Mitsubishi Electric AC Servo System

No.24-03AE

Battery Label Change in Compliance with EU Battery Regulation

Example (for Q6BAT)

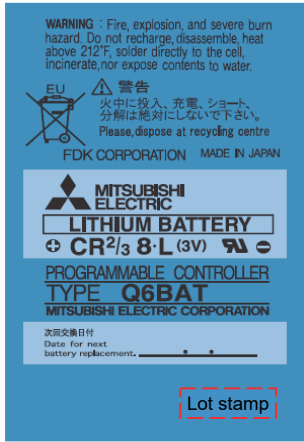
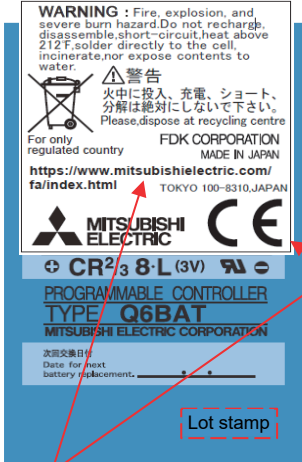
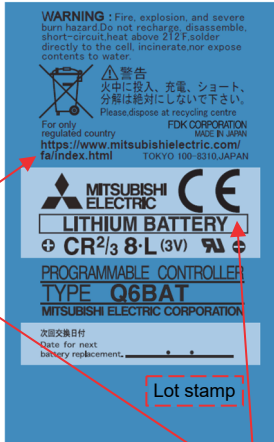
To comply with the EU Battery Regulation, the following indications have been added to the battery.

- CE mark
- The address of the manufacturer
- The URL of the manufacturer

For the label of some Q6BAT products, stickers have been affixed in response to the change.

Before	After
	<div><div>[Product with a sticker affixed]</div><div>The address and URL of the manufacturer have been added.</div></div> <div><div>[Products with the label changed]</div><div>The CE mark has been added.</div></div>
